Addendum No. 5

Reference: George S. Eccles Student Life Center
University of Utah – Salt Lake City, Utah
DFCM Project No. 08015750

Addendum No. 3 Issued: 06/11/13

Addendum No. Three
for the
Student Life Center
Bid Package
MHTN Project No. 2010562

AD03-C6.0

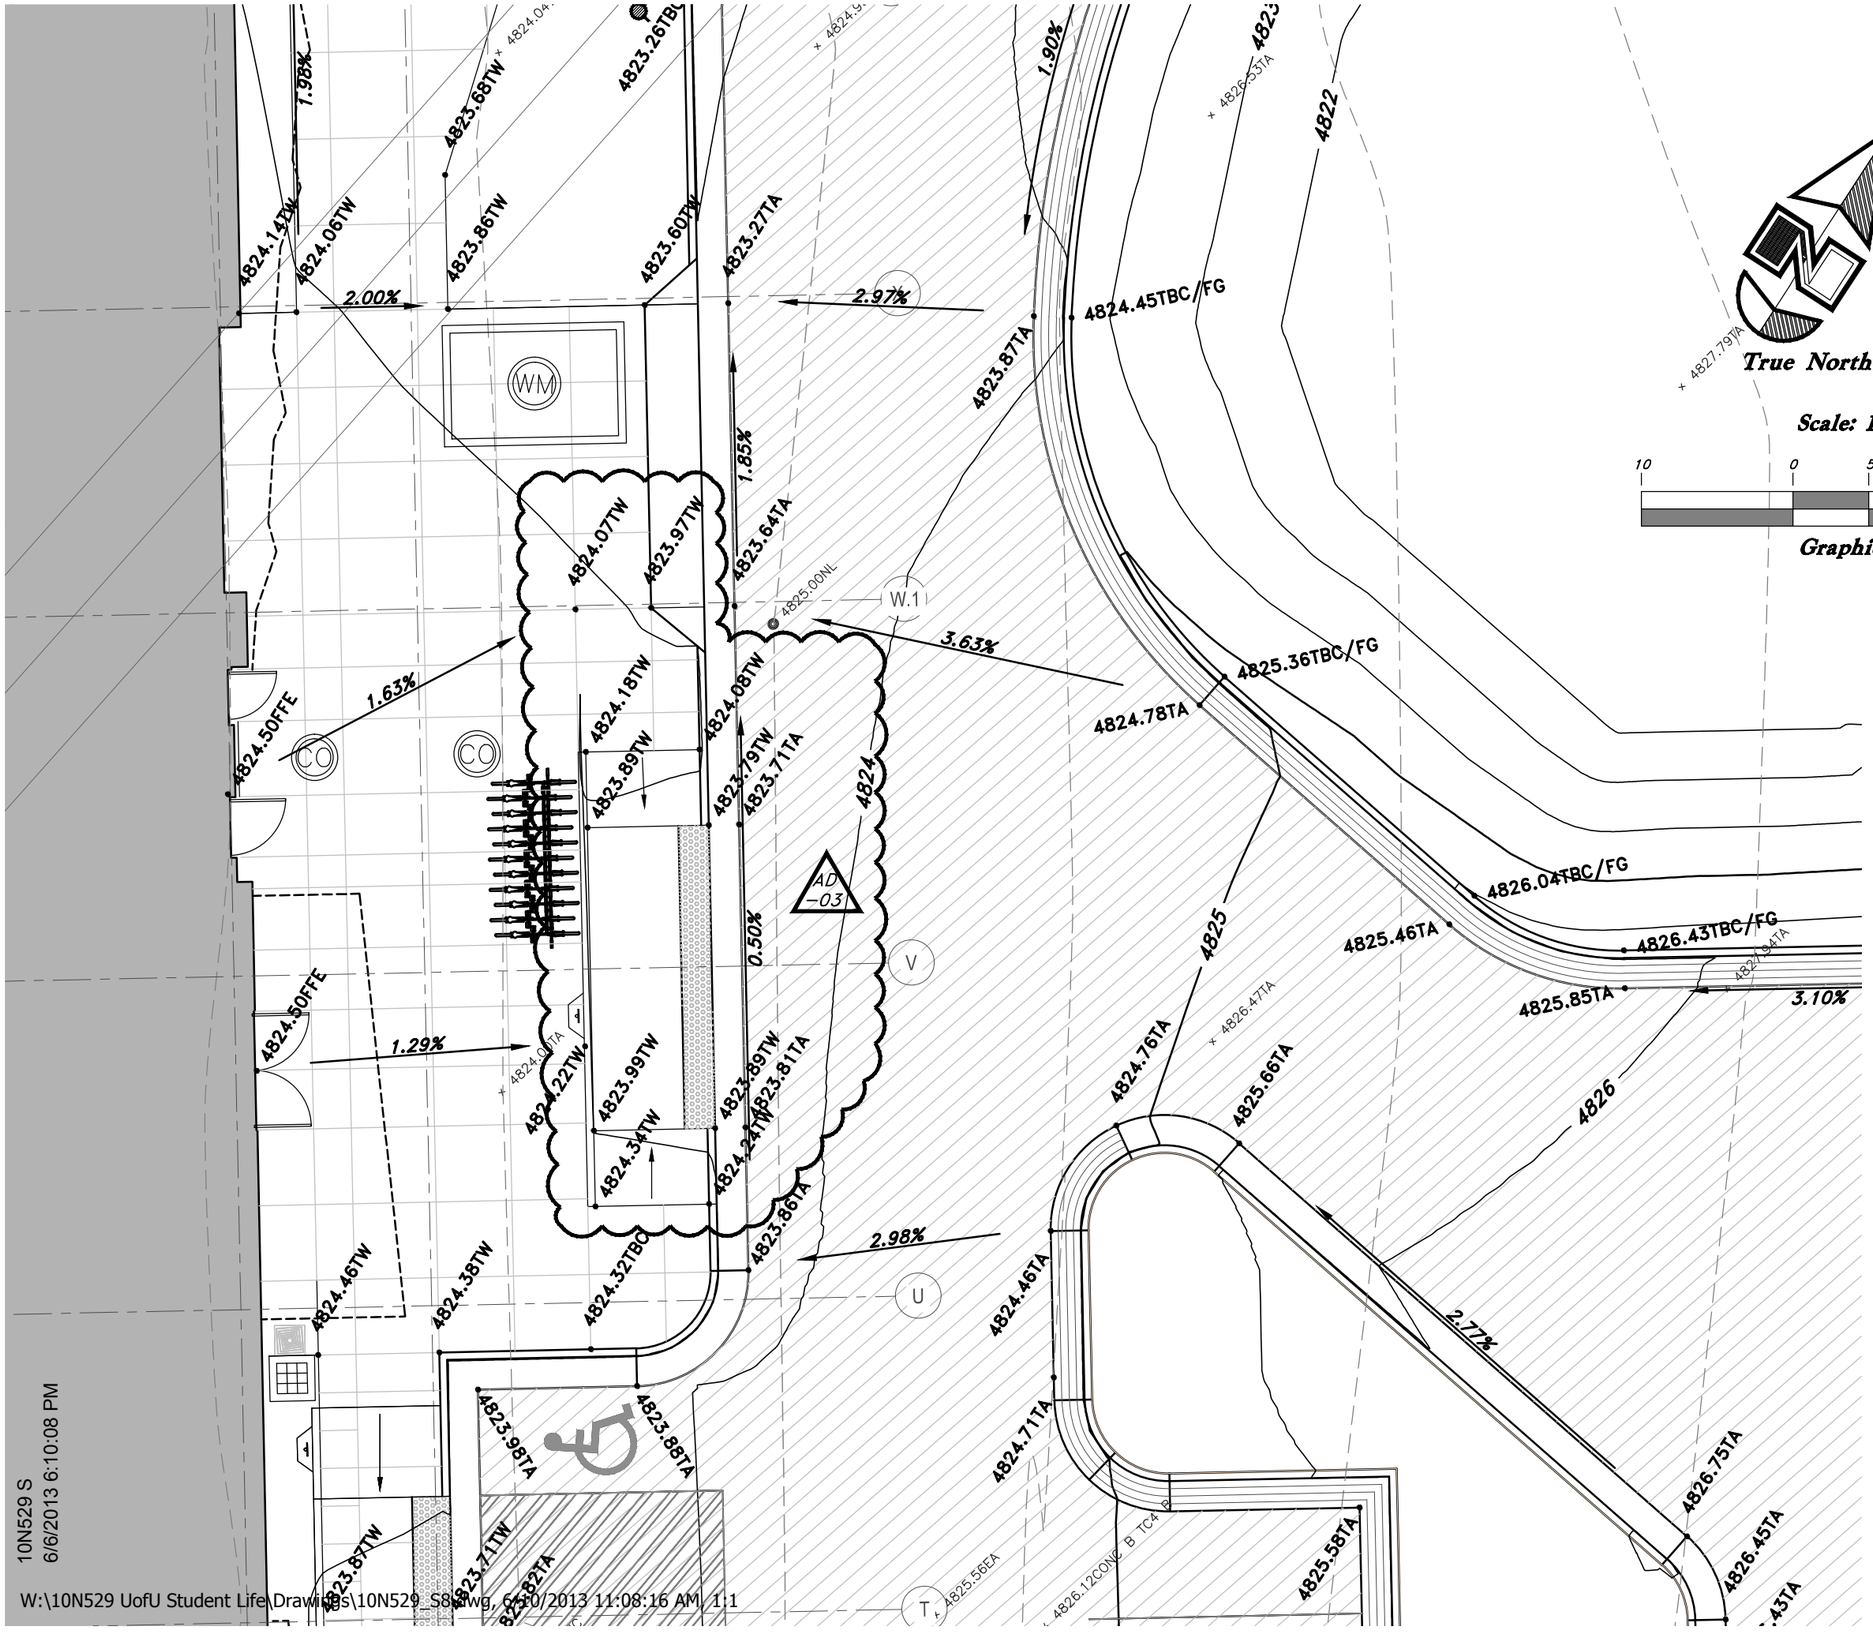
A3.30 Sheet CU302 & CU302a

1. Added a non-freeze yard hydrant to North side of Storage Building. **AD03-C6.0**
2. Added 1" dia. Water line to hydrant. **AD03-C6.0**

AD03-C7.0

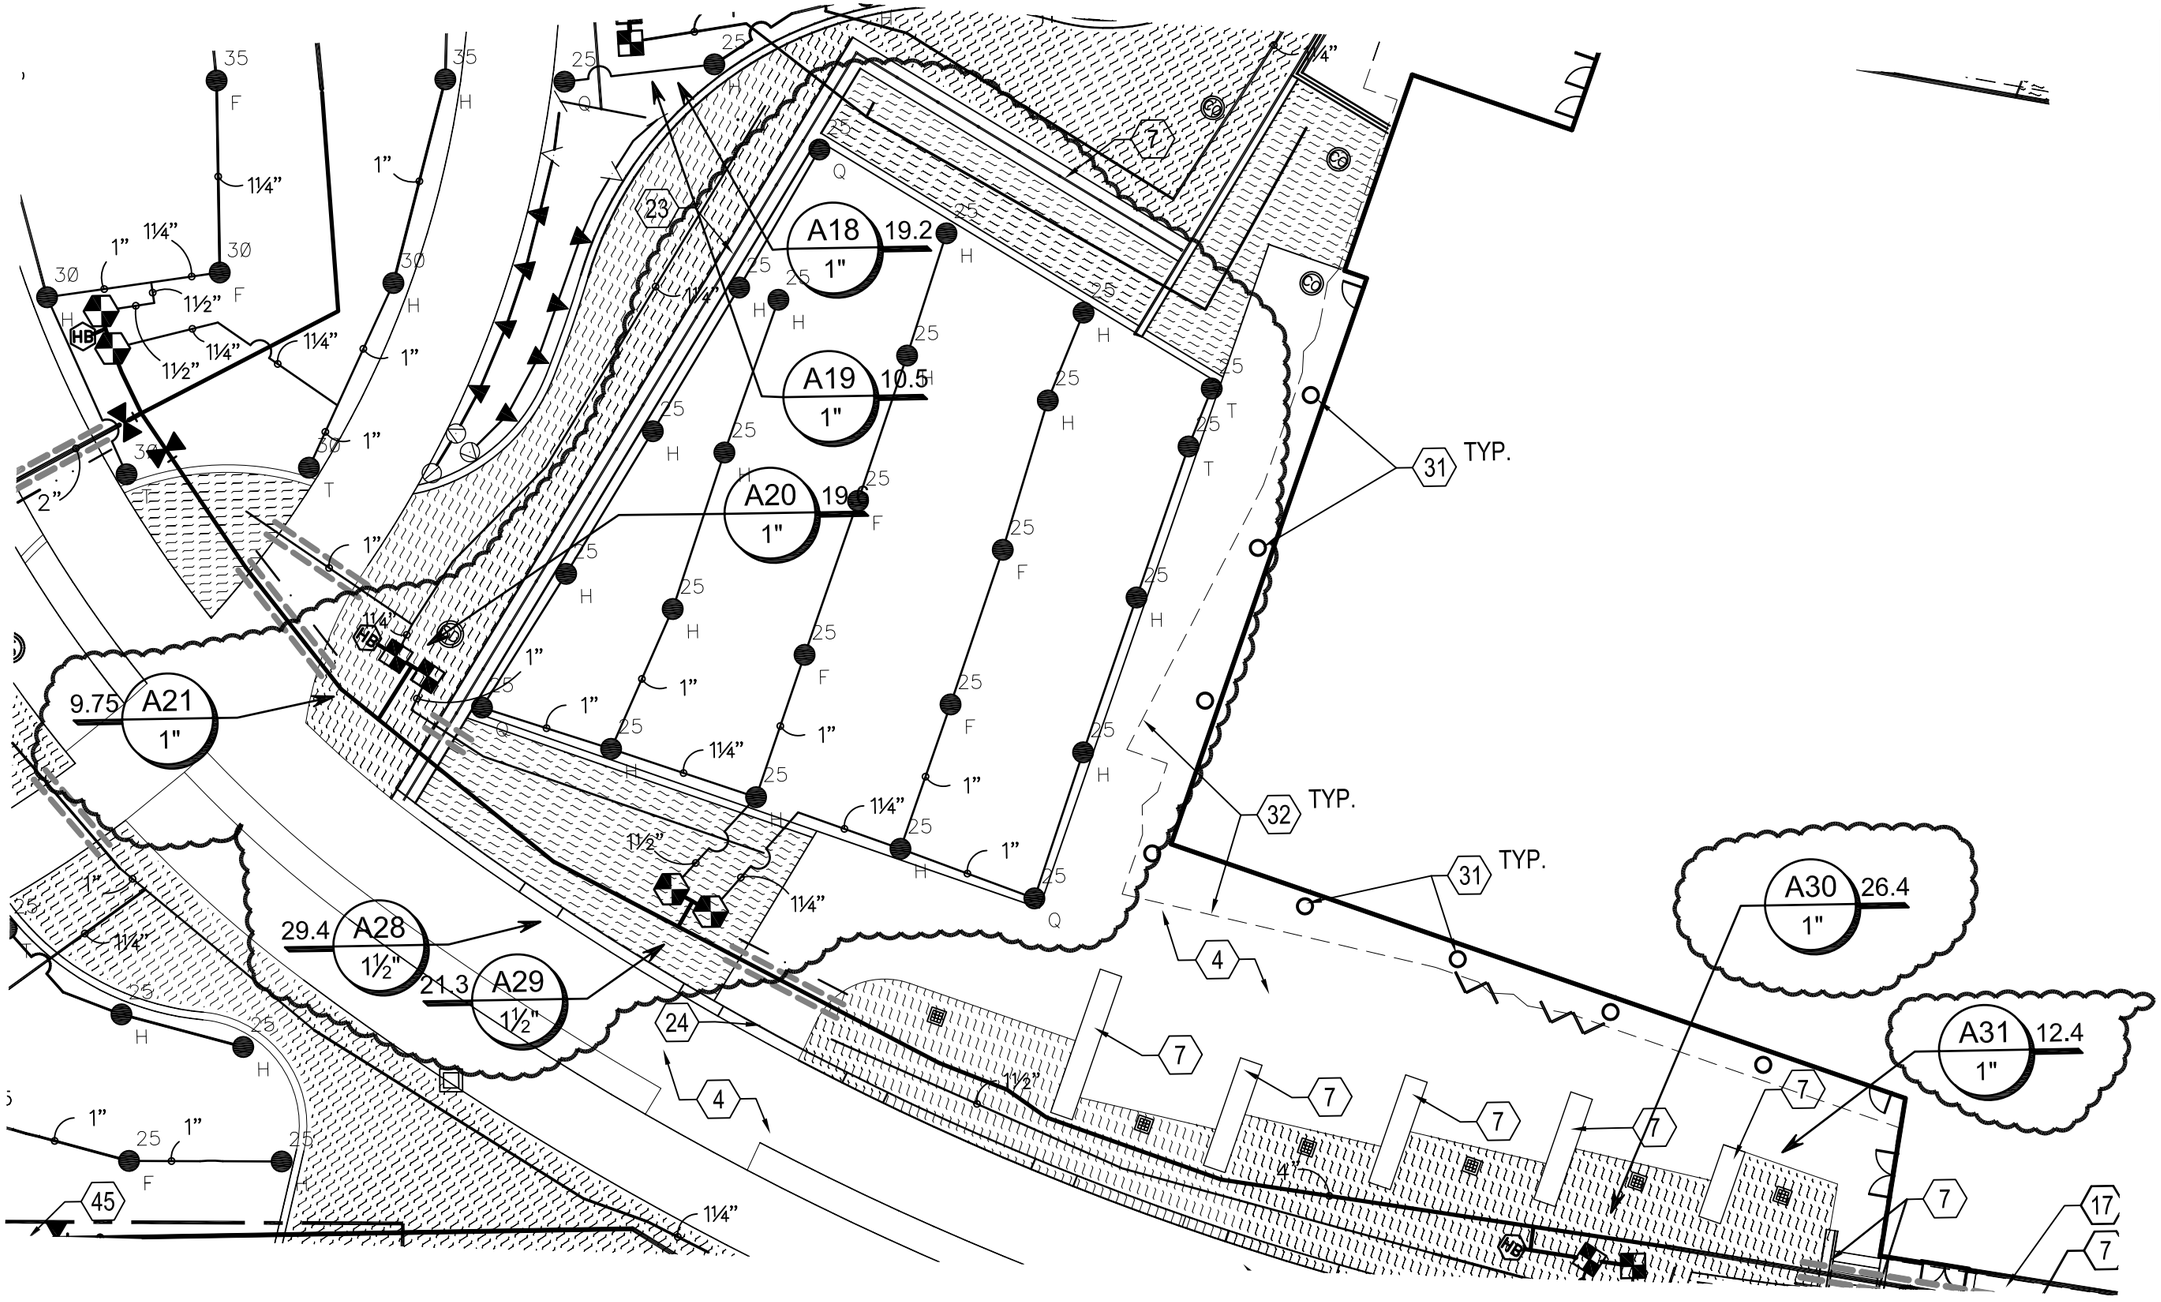
A3.31 Sheet CG202 & CG202a

1. Added grade spots to the new ADA drop-off ramp. **AD03-C7.0**

C4 / SF515 ALTERNATE SPLICE DETAILS FOR ACOUSTIC ROOF DECK

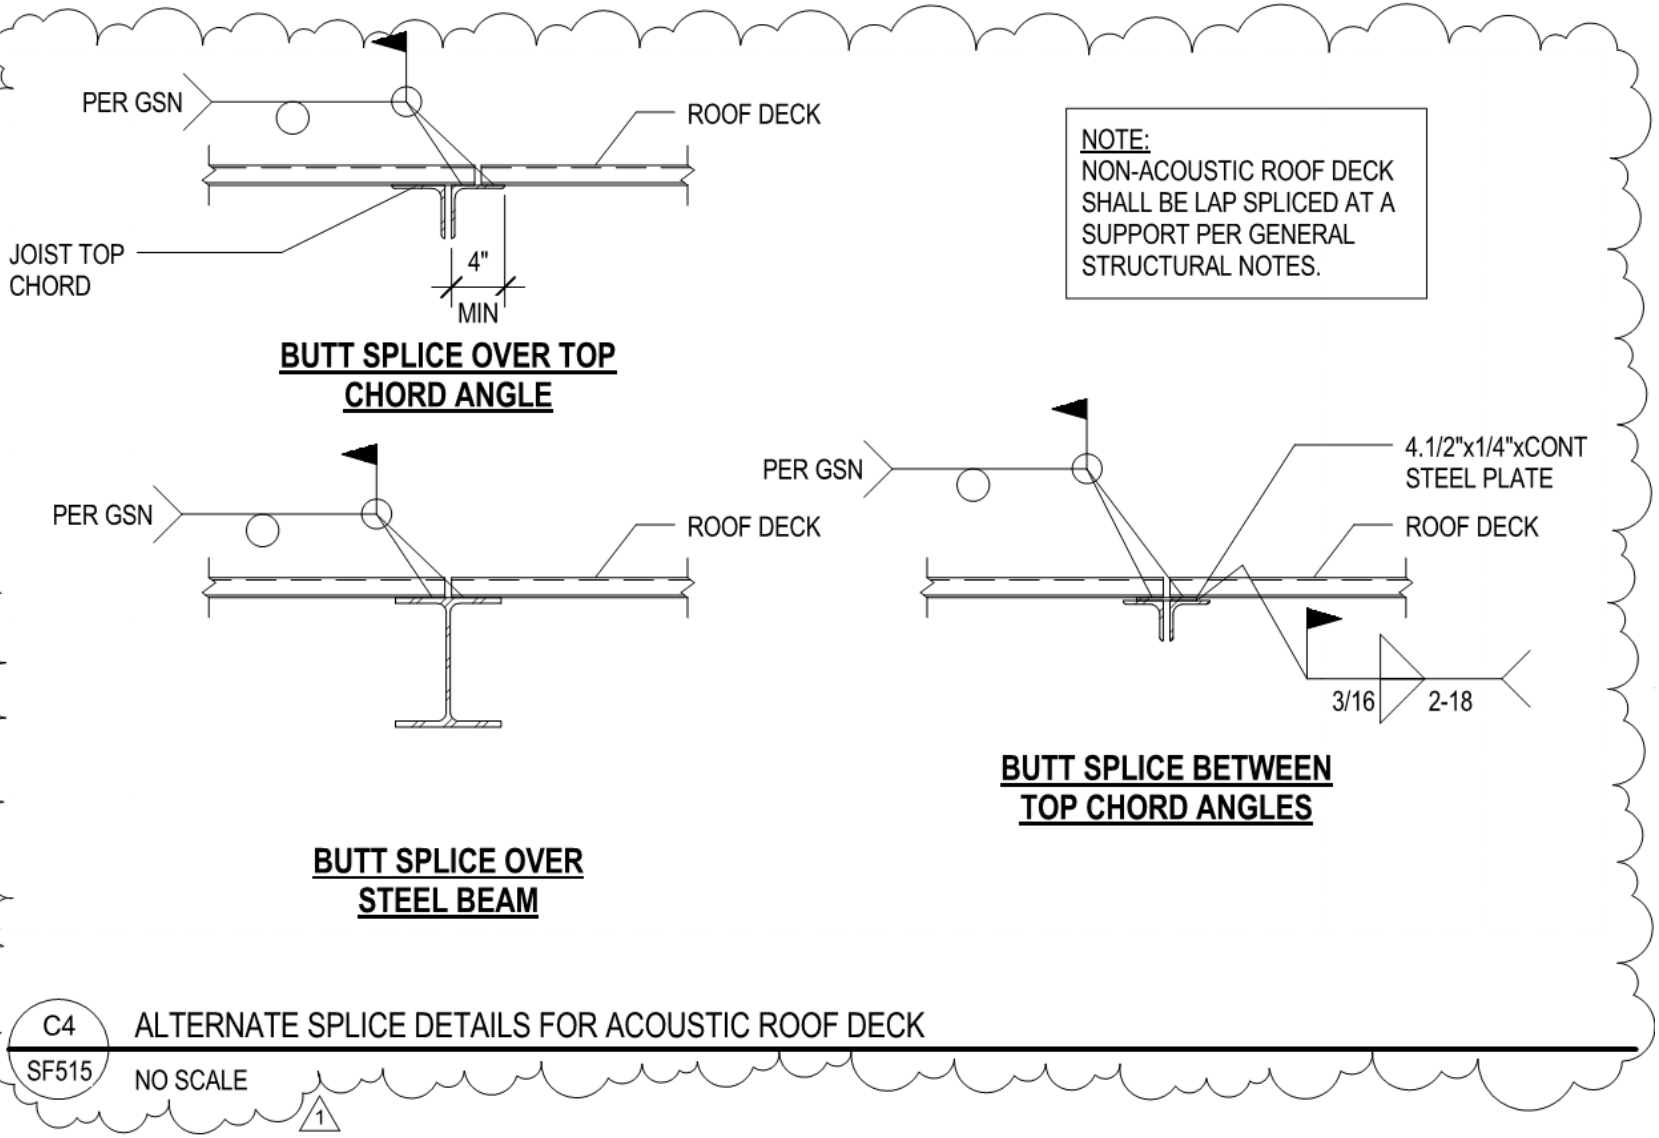
A3.42 Sheet SF515:

1. Add detail C4/SF515.

1 EL200.C1 LOWER LEVEL RCP PLAN ALTERNATE 1A
SCALE |1/8" = 1'-0"

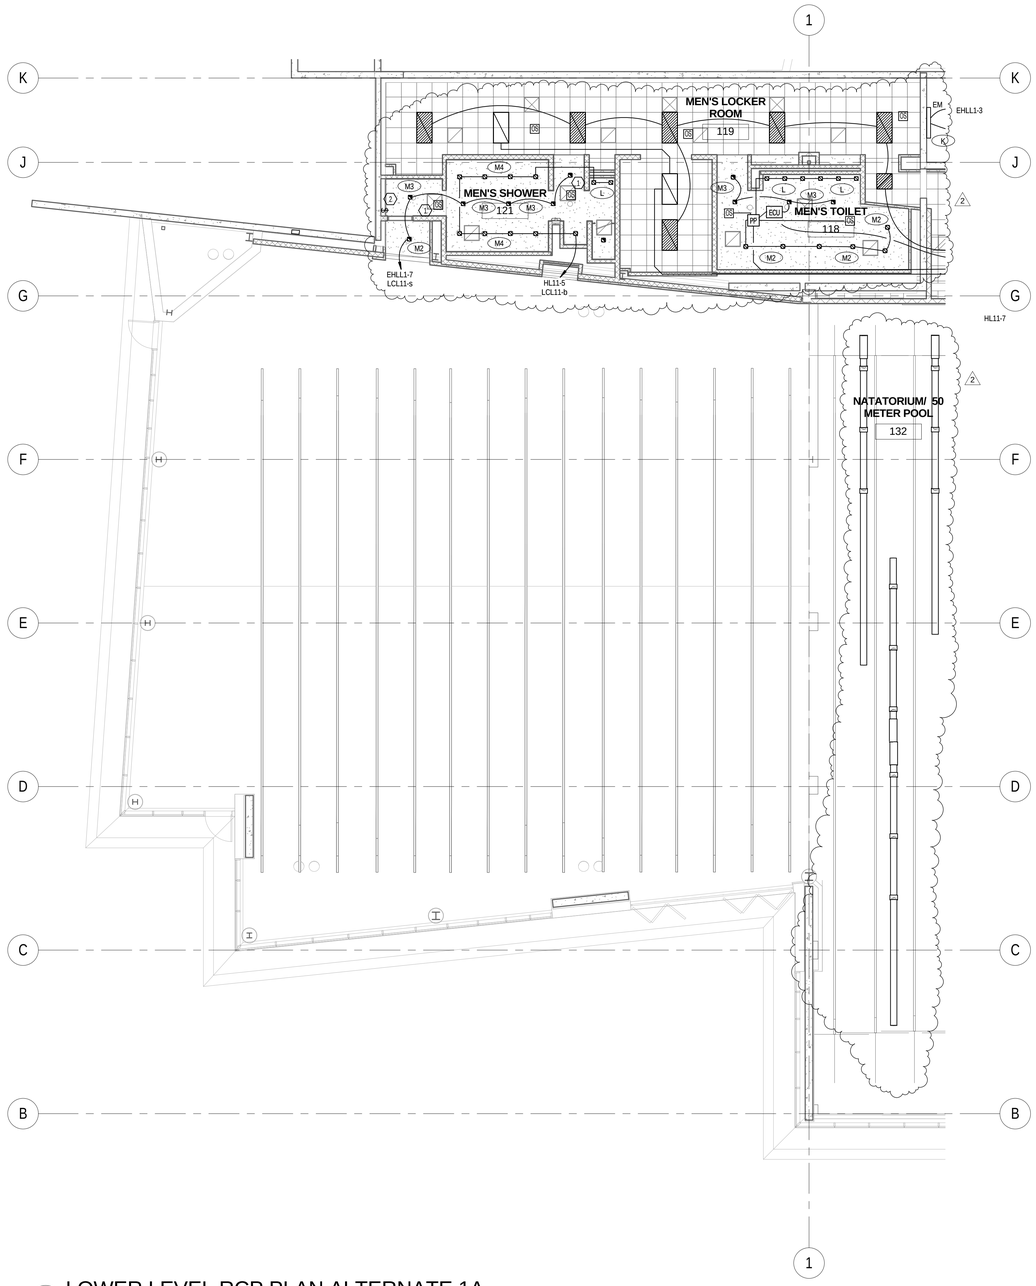
A3.112 Sheet EL200.C1 – Lower Level Lighting Plan – Alternate 1A

2. Change: Added lighting layout for men's toilet 118; see plan.
3. Change: Relocated lighting over the 50 meter pool 132 to sheet EL201.C1; see plan.
4. Change: Added corrected homerun EHLL1-7 for lighting in men's shower room 121 area.
5. Change: Added corrected homerun HL11-5 for lighting in men's shower room 121.
6. Change: changed note call out #1 to #2 by the lighting switch in men's shower room 121 ar ea.
7. Change: Deleted note C from general note.

1 EL200.C2 LOWER LEVEL RCP PLAN ALTERNATE 1B

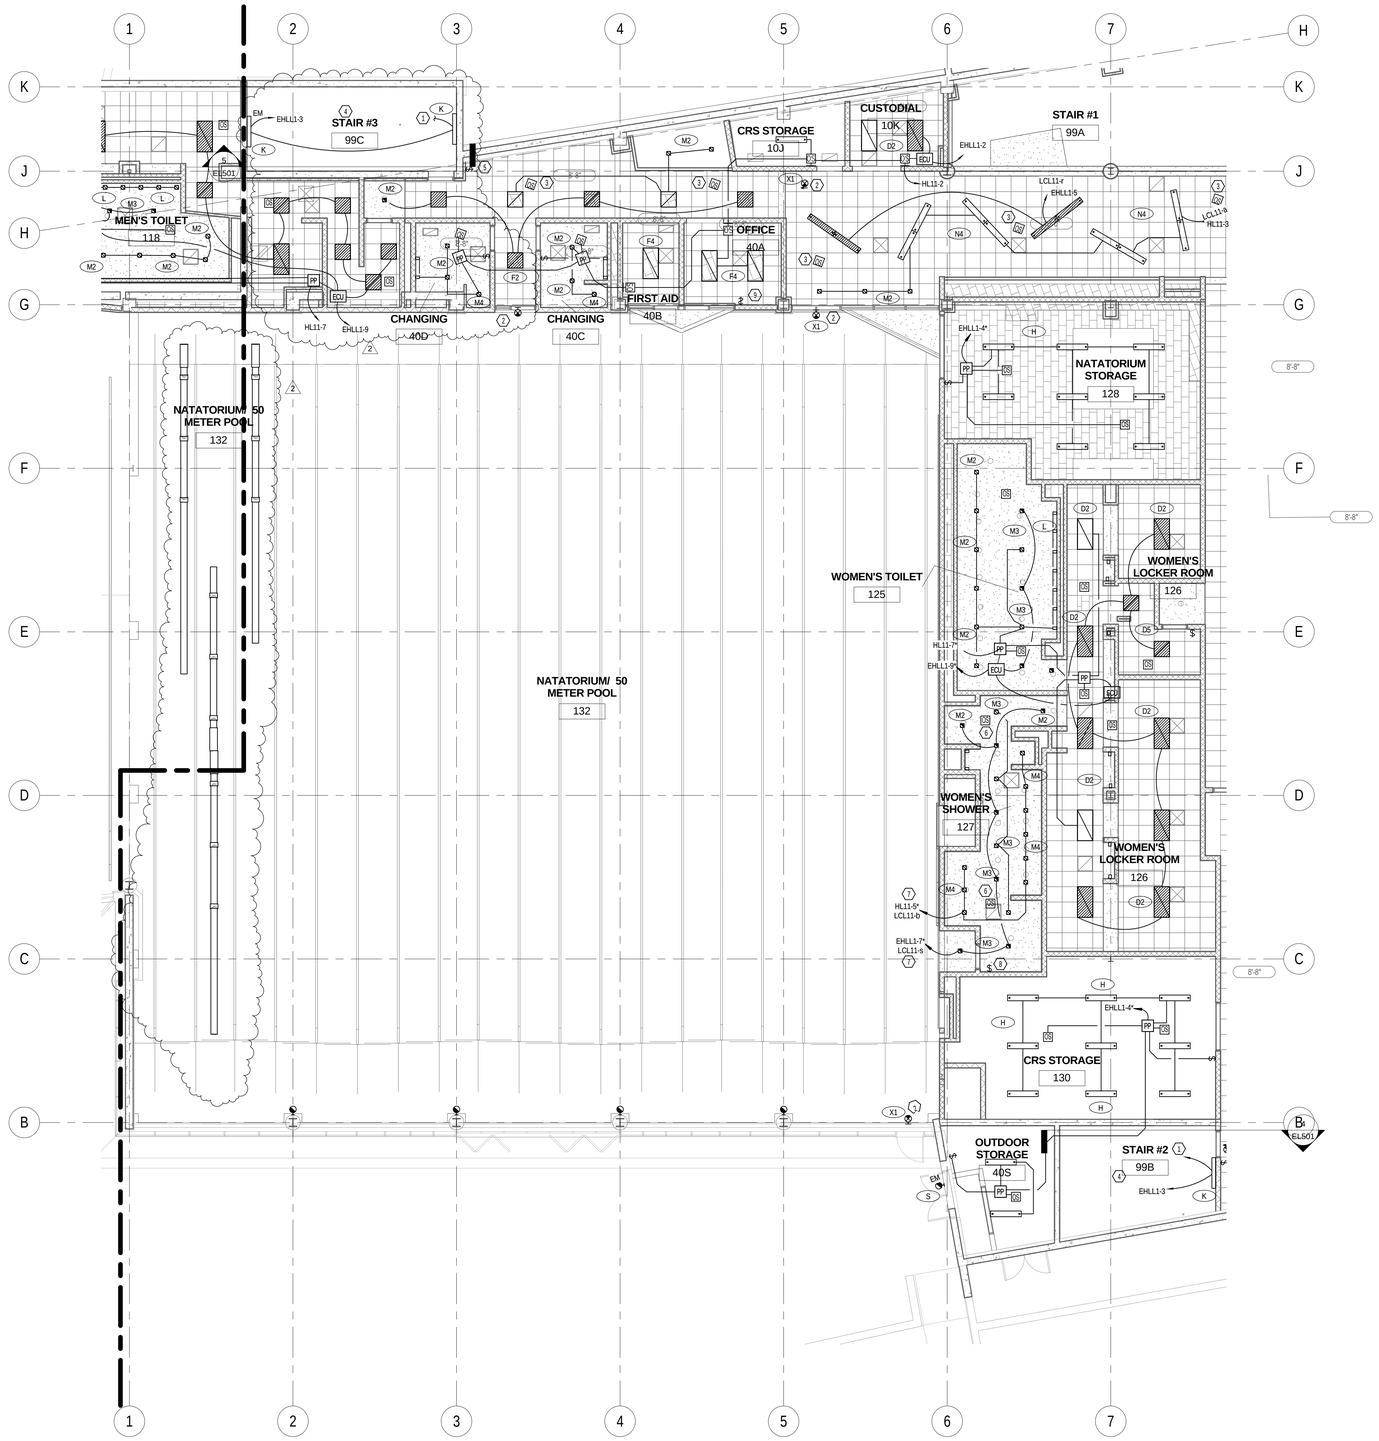
A3.113 Sheet EL200.C2 – Lower Level Lighting Plan – Alternate 1B

1. Change: Added lighting layout for men's locker room 119 entrance; see plan.
2. Change: Relocated lighting over the 50 meter pool 132 to sheet EL201.B; see plan.
